Delegated Report

Planning Application No: 20231001

Location: 232 Singlewell Road Gravesend Kent DA11 7RE

Description: Demolition of existing bungalow and erection of two storey dwelling with rooms in the roofspace, erection of outbuilding in rear of garden to form a gym, erection of bin store to front, alteration of existing frontage to create hard standing for parking, new boundary including existing access.

Existing and Proposed Streetscene Views:

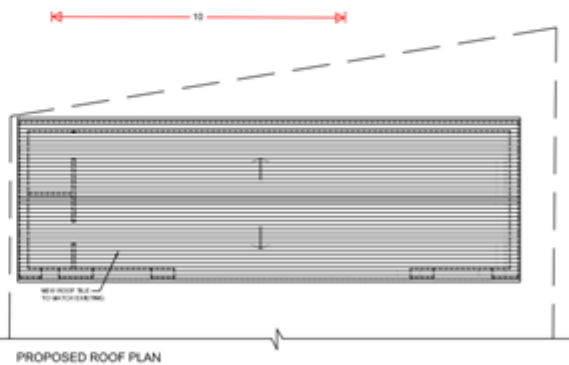
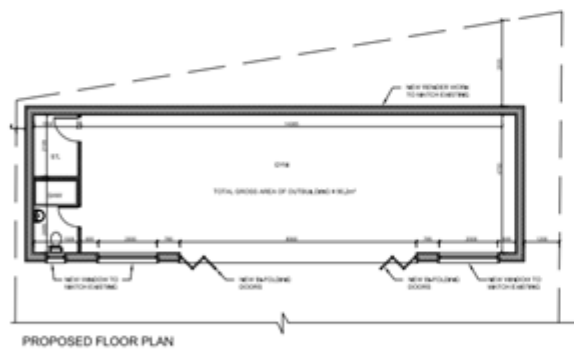
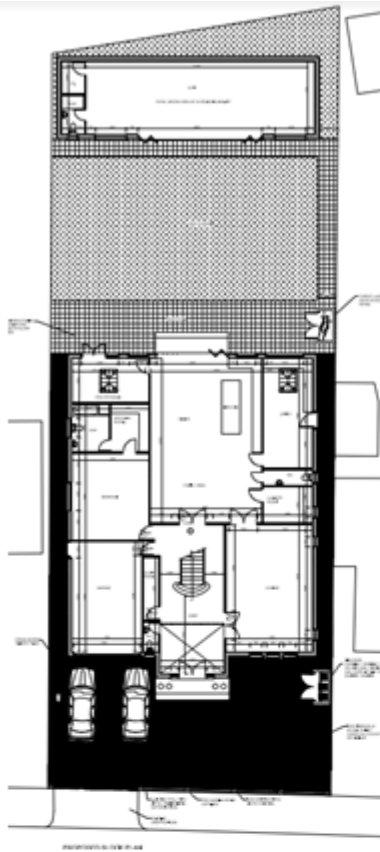
The proposed streetscene view shows however, that the proposed two storey dwelling would not only be much taller than the immediate bungalow to the north but also the immediate two storey dwelling to the south no. 234. The proposed dwelling would be much larger than even the two storey dwellings to the south in respect of both footprint and depth. Indeed the dwelling would be so large that it would have to have a part flat/part pitched roof which is not in keeping with the roof forms in Singlewell Road. The full two storey height of the dwelling combined with a full deep roof with dormers would add to the bulk and massing of the dwelling. The other two storey dwellings in the immediate streetscene do not tend to have such a large bulky roof with dormers on top when they are already a full two storeys.

In summary, although there are large dwellings in Singlewell Road, the immediate context has to be considered. No. 232 is located in between bungalows to the north and two storey dwellings to the south but the proposed dwelling would be larger and more dominant than these which is not considered acceptable as discussed above.

The proposed replacement dwelling by virtue of its size, bulk, massing and design would be an overly dominant and incongruous form of development which would not be in keeping with the immediate streetscene it is situated in. The positive contribution that the existing dwelling makes to the streetscene would be replaced with a development that would cause harm to the character and appearance of the streetscene. In this respect the proposal is contrary to Policy CS19 (LPCS) and section 12 of the NPPF (2023).

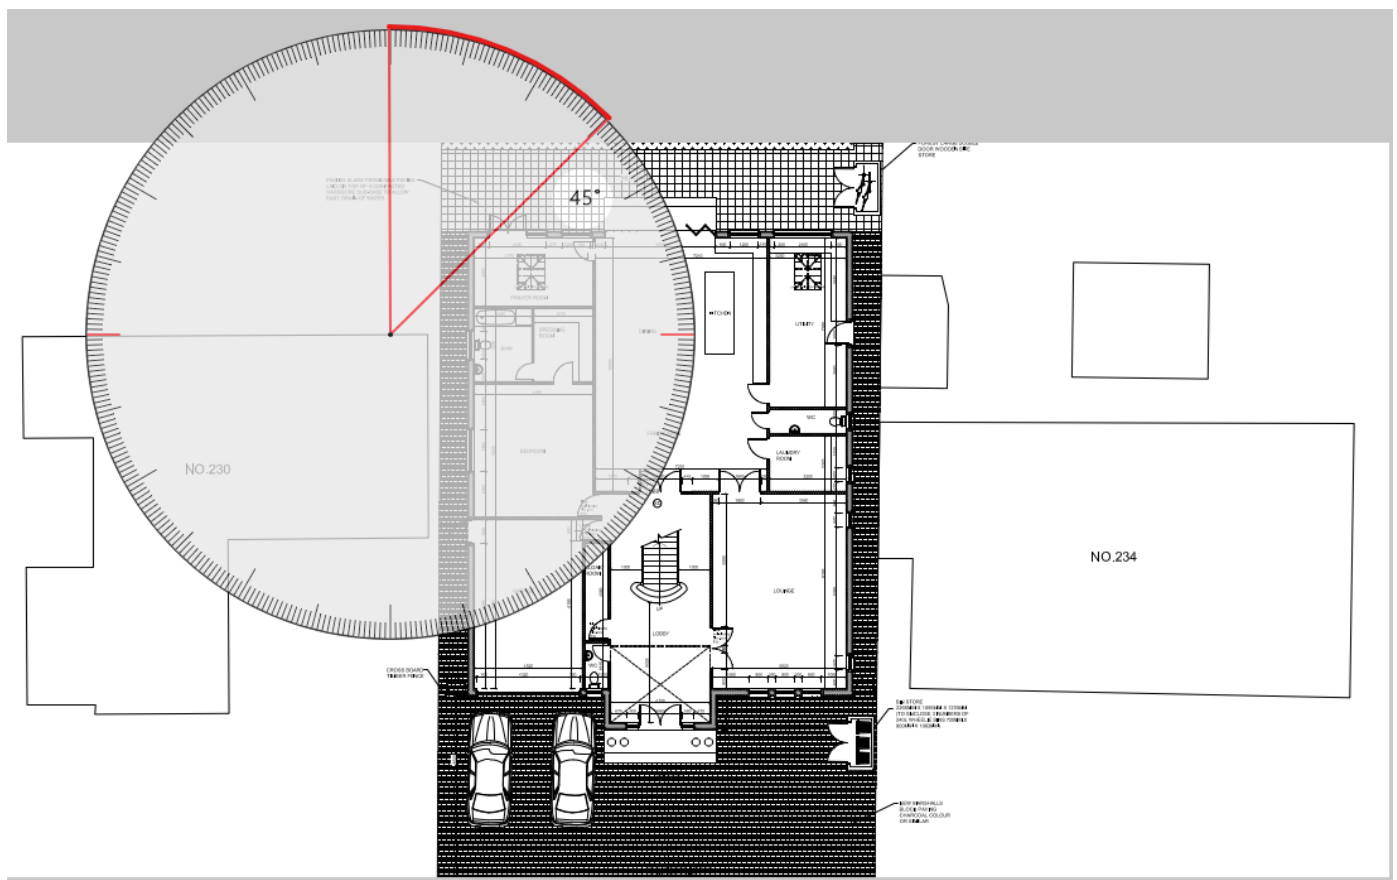
The above includes the whole of the garden to the rear including the outbuilding and the area behind and to the side of it. Even if this is not included and it is only the garden area in front of the outbuilding that is calculated this would still be a garden area of 255 sq. m and depth of 13.8m.

The garden area and depth of the property would therefore far exceed the minimum standards as set out in SPG2 (2020).

45 degree test on plan from nearest rear window:

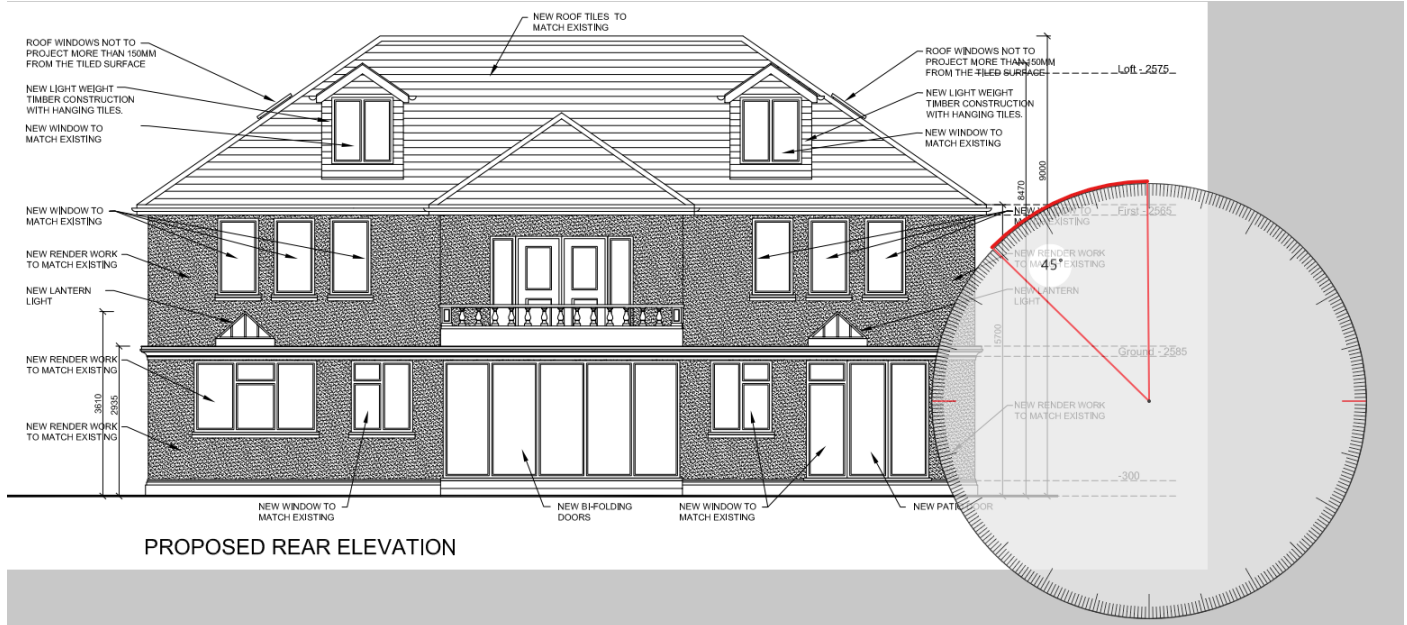
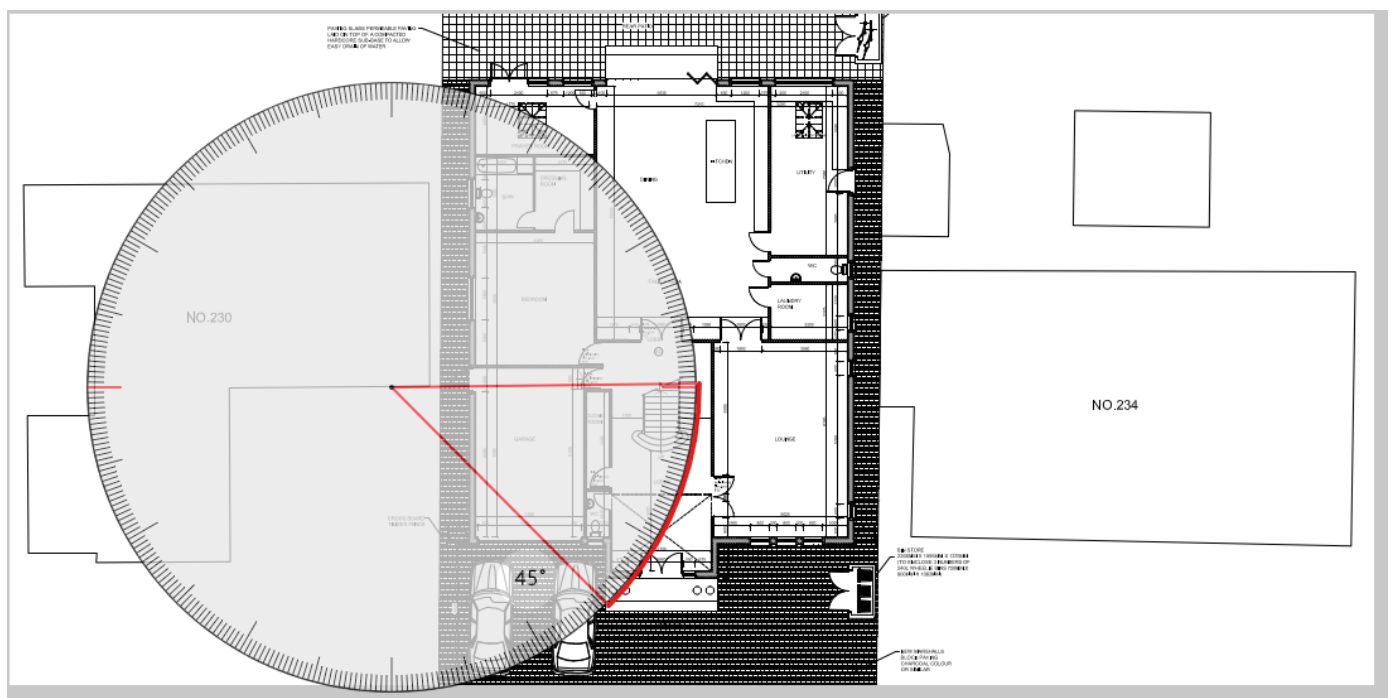
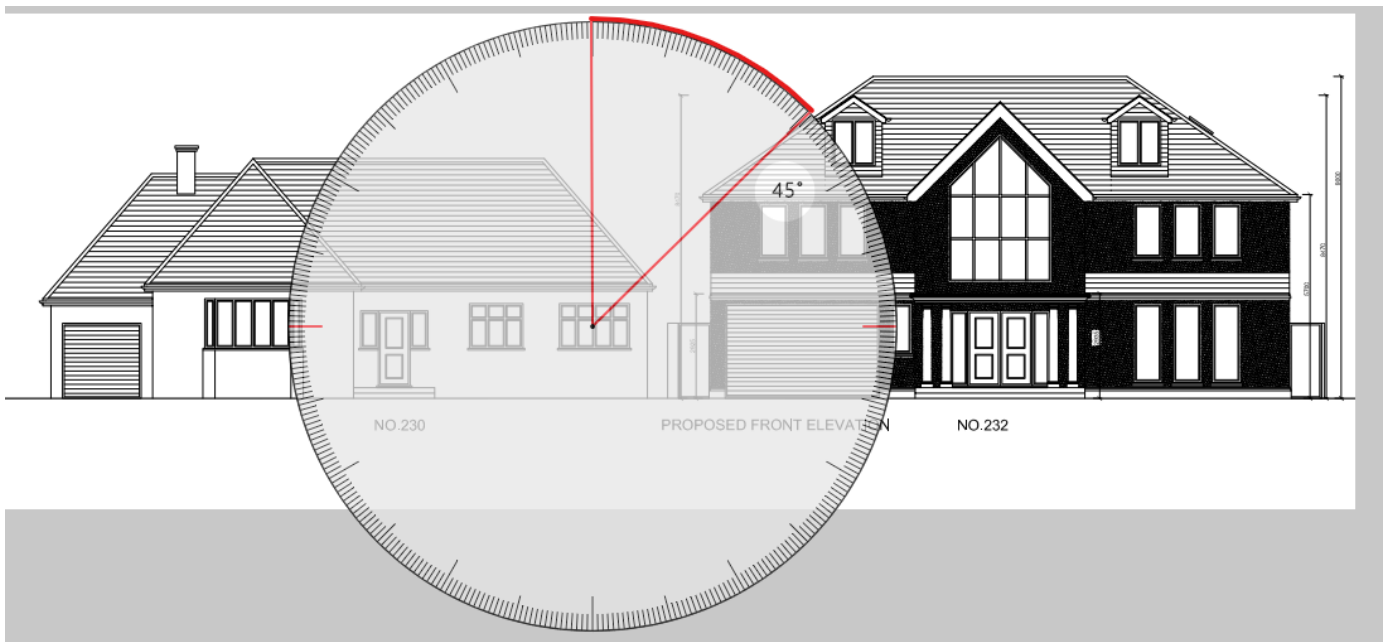
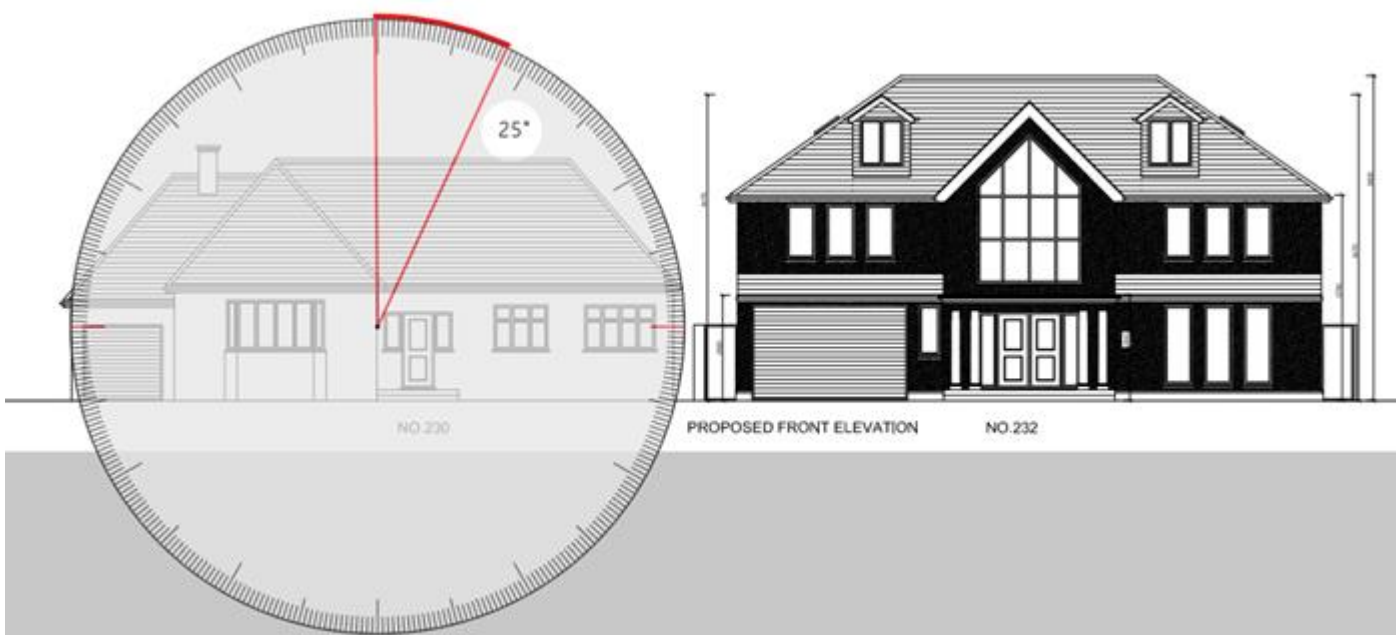
As can be seen the proposed dwelling would project slightly beyond the 45 degree lines from the nearest rear and front window on both plan and elevation thereby denoting some overshadowing and overbearing to the nearest front and rear windows of no. 230.

The proposed dwelling would not project beyond the 25 degree line from the nearest perpendicular windows.

Due to its sheer size with the dwelling being some 20m in depth and its height and proximity to no. 230 it is considered it would have a very overbearing impact on no. 230 and would generally be an unneighbourly form of development.

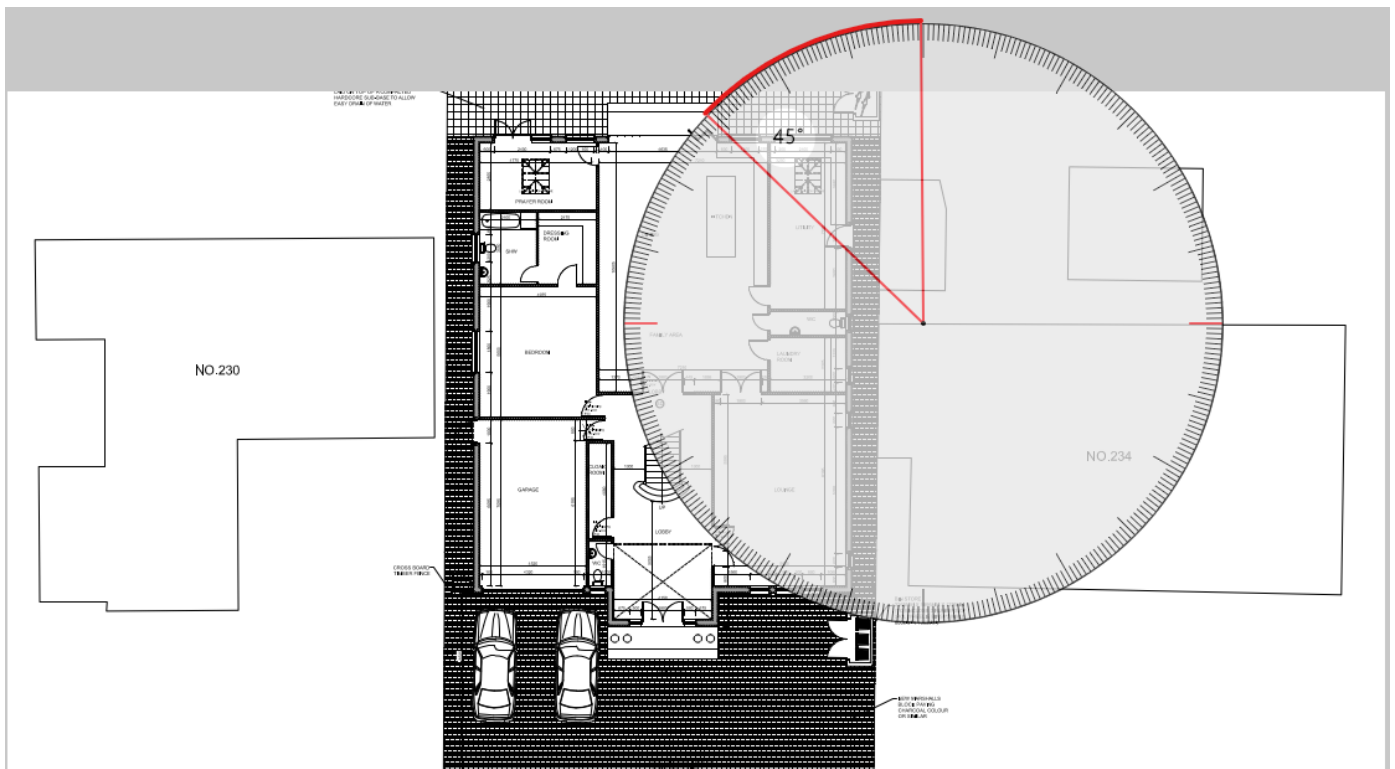
The proposed balcony at first floor level would result in overlooking to the private rear garden area of no. 230 and afford oblique views back into the rear windows of no. 230. Due to the scale of the dwelling, its

height and proximity to no. 230 it is considered some of the habitable room windows proposed such as the nearest bedroom windows and study door at first floor and entertainment room window at second floor would all lead to overlooking or as a very minimum a perception of overlooking to the occupiers of no. 230 and their private garden area.
